Stillwater Mine Revised Waste Management Plan and Hertzler Tailings Impoundment

Final Environmental Impact Statement

Type of Statement: Final Environmental Impact Statement

Proposed Action: Revision of Stillwater Mining Company's Existing Waste Management Plan and the Construction and Operation of the Hertzler Tailings Impoundment

Alternative B
Location of Primary Facilities
Comprising the Proposed Action
Figure 2-2

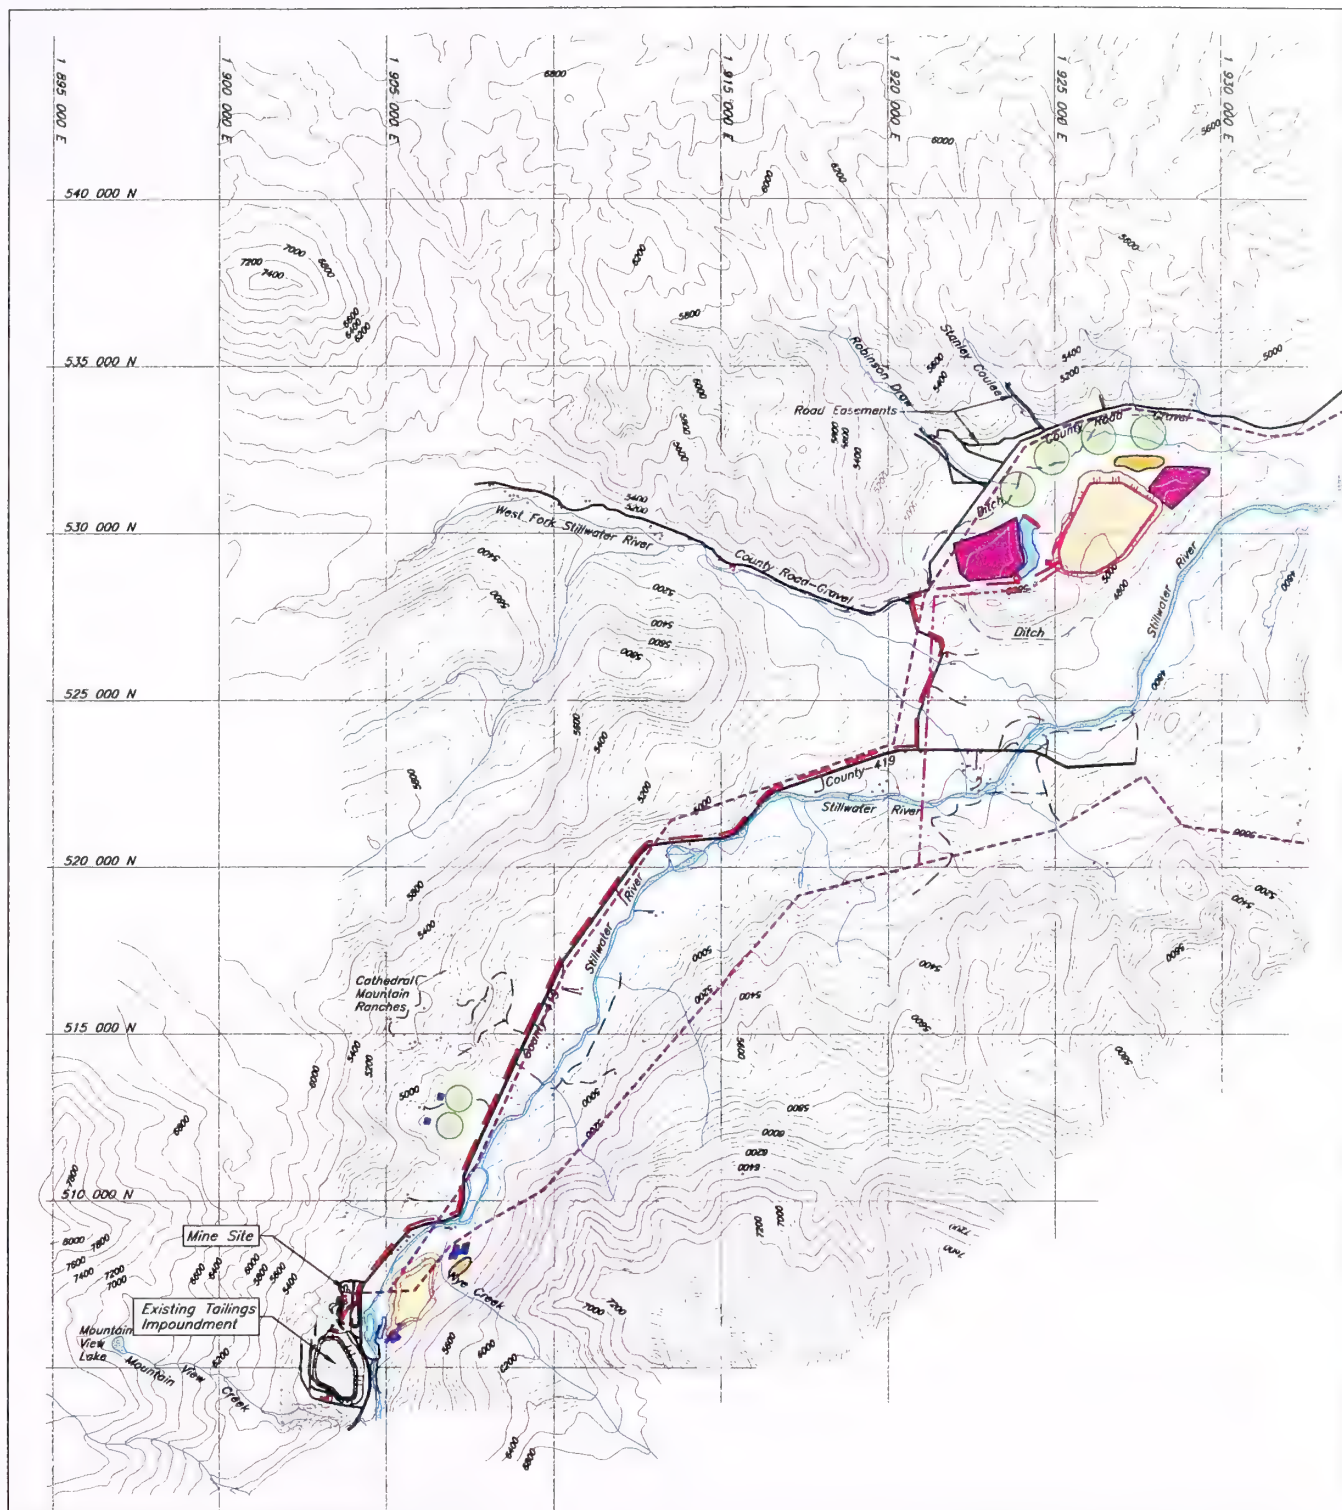
10. *Assuming Figure 2-2 is wrong and 2.4.2.3 is correct, each of the two 800-ft diam. LAD center pivot irrigation systems, operating continuously (24 hrs per day) for 7 months every summer (about 210 days/yr), will produce 300 gpm/pivot. This area receives 15-20 in. precipitation each year. How much additional water does this contribute to the 92+ acres under the pivots and how will this effect those acres? If my computations are correct, each acre under each pivot will receive nearly 290 in. of moisture over and above the annual precipitation, not accounting for evaporation between the spray head and the ground or wind. Given this much added water to these two sites, it seems very certain ground water will mound under the area and that instability of the toe of the colluvial material will occur. It is not a "should ground water mounding" occur issue. What are the consequences of the resulting instability and how might SMC control it? (9)*

3. *Assuming Figure 2-2 is wrong and 2.4.2.3 is correct, each of the two 800-ft diam. LAD center pivot irrigation systems, operating continuously (24 hrs per day) for 7 months every summer (about 210 days/yr), will produce 300 gpm/pivot. This area receives 15-20 in. precipitation each year. How much additional water does this contribute to the 92+ acres under the pivots and how will this effect those acres? If my computations are correct, each acre under each pivot will receive nearly 290 in. of moisture over and above the annual precipitation, not accounting for evaporation between the spray head and the ground or wind. Given this much added water to these two sites, it seems very certain ground water will mound under the area and that instability of the toe of the colluvial material will occur. It is not a "should ground water mounding" occur issue. What are the consequences of the resulting instability and how might SMC control it? (9)*

Response: Figure 2–2 has been corrected to show the proposed LAD pivots.

Response: **Figure 2-2** has been corrected to show the proposed LAD pivots.

In 1996, MSE-HKM (1997) estimated that the two half-pivots at the mine site each sprayed 500 gpm or 322 acre-feet of water resulting in the equivalent of 93.2 inches of rainfall. This is equivalent to five times the annual precipitation of 18.3 inches. The Stratton Ranch is located on the edge of the Stillwater River floodplain. Water within the alluvium recharges the river during all but the highest surface water flow periods, with net flow to the east. The ground water table in this area slopes eastward toward the river (**Figure 3–2**). Review of historic data from the LAD systems at the east side SMC facilities area suggests that mounding doesn't occur. The materials underlying the Stratton Ranch site are suited to handle a large throughput of water with nominal effect to the adjacent slopes as evidenced when a trailer park occupied the site and had a leach field that handled 150 to 250 gpm. **Section 4.1.1.2.2** has been revised to reflect this information.

Response: The LAD sites have been added to **Figure 2-2**.

Hertzler Impoundment Typical Cross
Section of the Embankment
Figure 2-5

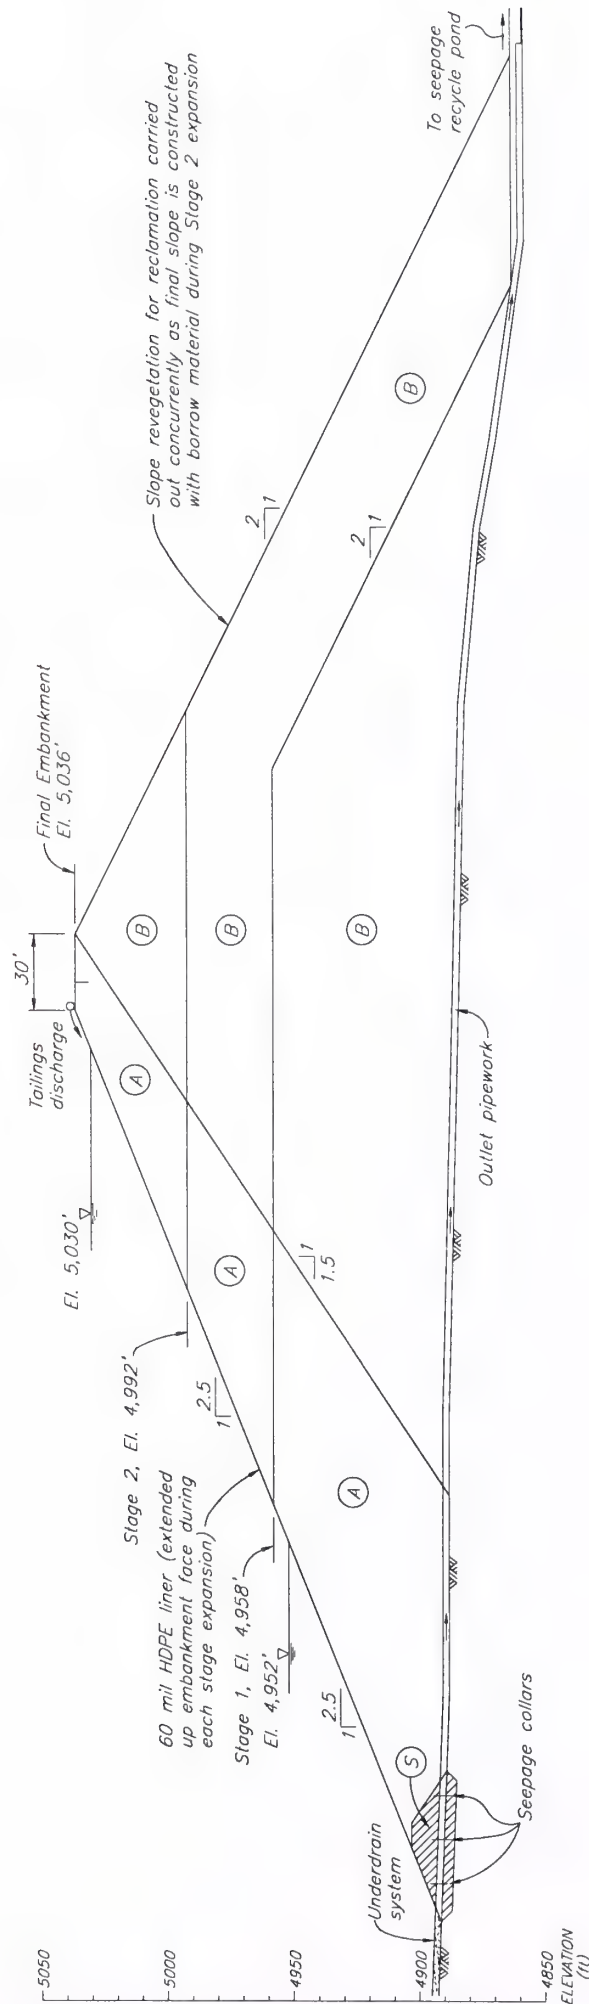
6. *Figure 2-5 shows the design for the embankment of the Hertzler tailings impoundment. The upstream slope, facing the interior of the impoundment will have a slope of 2.5H:1V. The downstream side of the embankment is proposed with a slope of 2H:1V. While a 2H:1V minimizes the area covered by the embankment, revegetation of a 2H:1V slope is generally considered to be problematic. (22)*

8. *Figure 2-5 shows the design for the embankment of the Hertzler tailings impoundment. The upstream slope, facing the interior of the impoundment will have a slope of 2.5H:1V. The downstream side of the embankment is proposed with a slope of 2H:1V. While a 2H:1V minimizes the area covered by the embankment, revegetation of a 2H:1V slope is generally considered to be problematic. (22)*

WATER RESOURCES
Hertzler Area (Part 1)
Figure 3-1

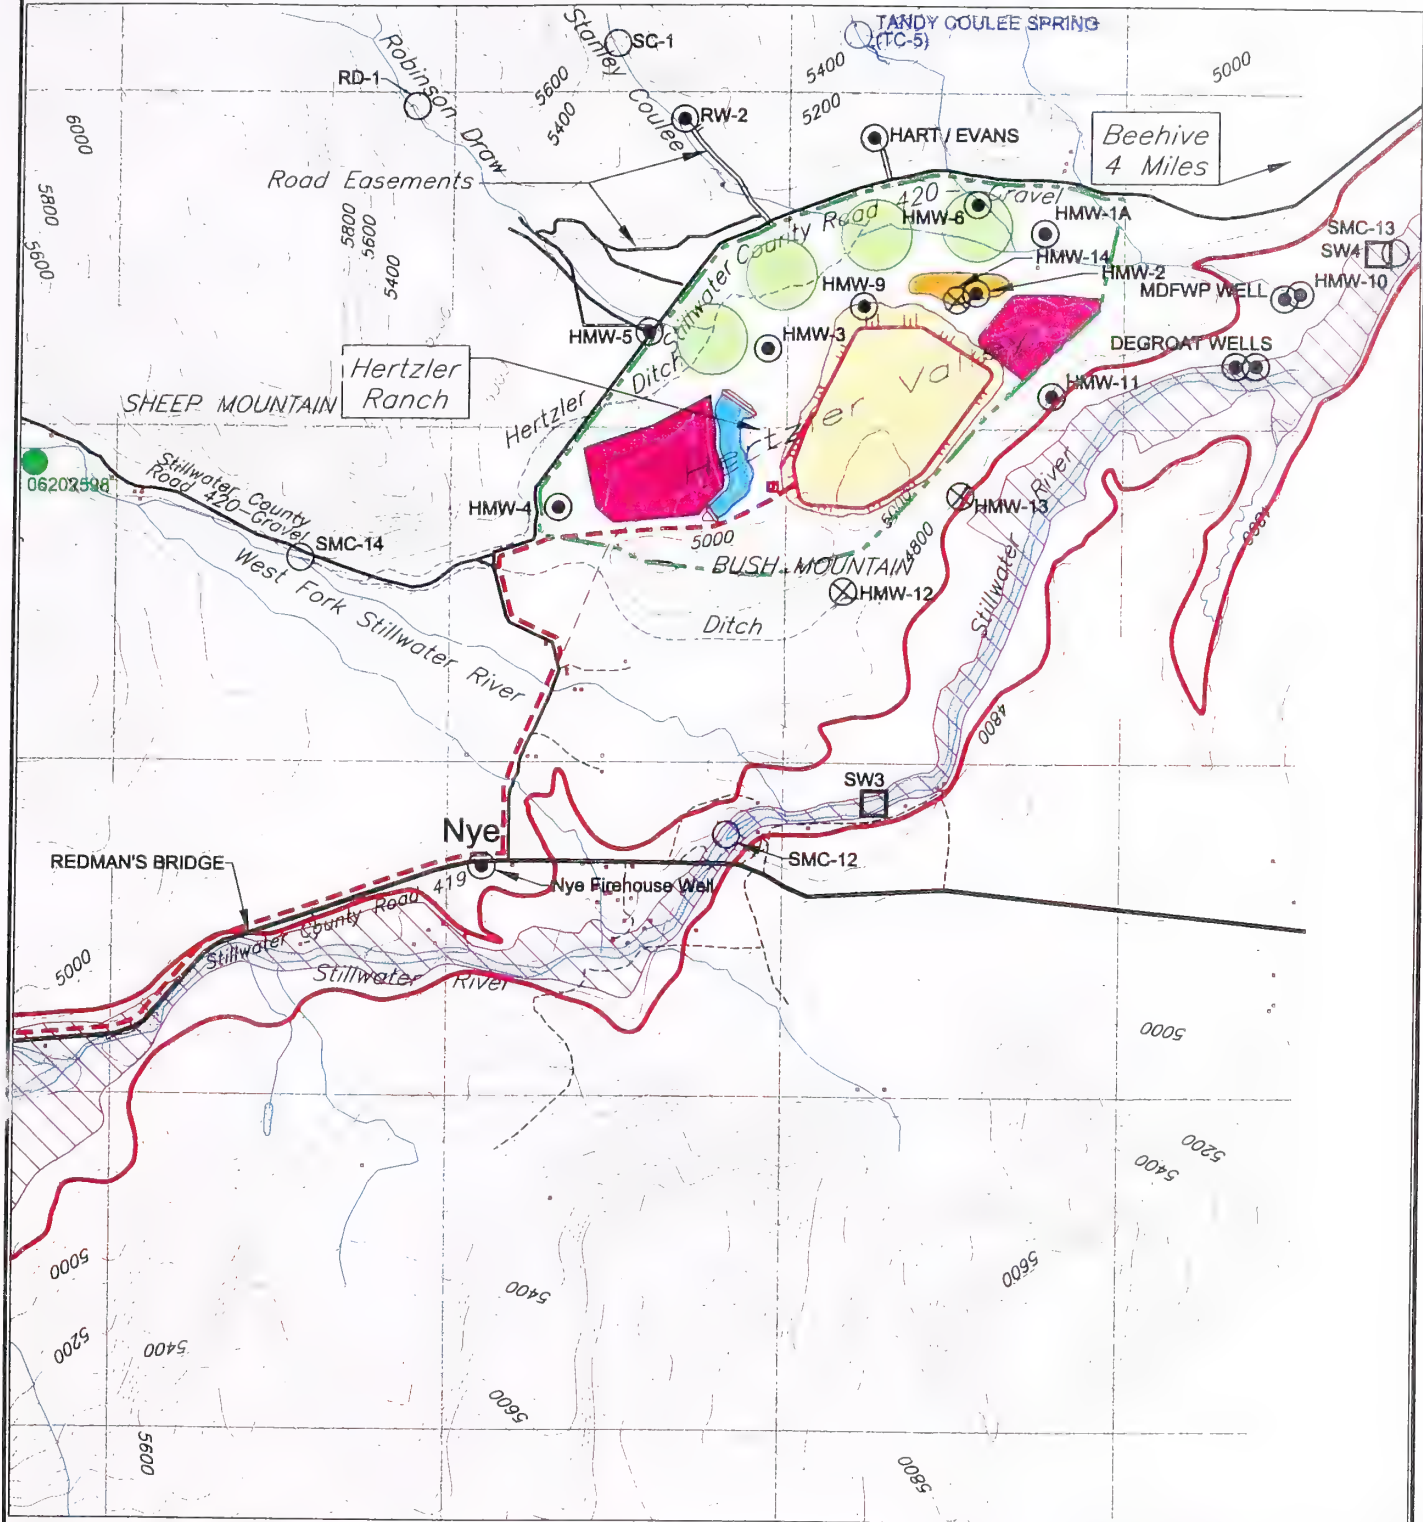
75. *In Figure 3-1, the Hertzler (irrigation) Ditch is shown to intersect the three western land application areas. The Robinson Draw ephemeral flow joins the ditch in the 1st (left to right) LAD pivot area. The Stanley Coulee (indicated to flow year-round) joins the Hertzler Ditch in the 3rd LAD pivot area. Both the Stanley Coulee and the Tandy Coal Mine Draw spring (said to flow year-round) flow into the 4th LAD pivot area. In regards to the heavy metals discharges at the site (adit discharges, spring runoff and ephemeral flows in Robinson Draw, Stanley Coulee and Tandy Coulee), EPA requests that consideration be given to design which would collect, contain and treat deleterious heavy metal discharges and flows. For example, one possible flowsheet for water treatment is to obtain heavy metal precipitation through lime precipitation in a redesigned (geomembrane-lined) Hertzler storage pond followed by pH adjustment prior to the point-of-compliance release to the LAD pivot system. (32)*

Response: **Figure 3–1** now shows the Hertzler Ranch as Hertzler Valley, which is the area referred to by the water resources narrative. Water rights listings from the Montana Department of Natural Resources and Conservation for the Hertzler Ranch area suggest all domestic surface water adjudications are derived from the West Fork or main stem of the Stillwater River. Atlantic Richfield has a well permit for one 98-foot deep domestic well in the area. Ground water quality is described in **Section 3.1.3.3**, where it now clarifies that the major limitations to domestic use are derived from federal secondary drinking water standards related to staining.
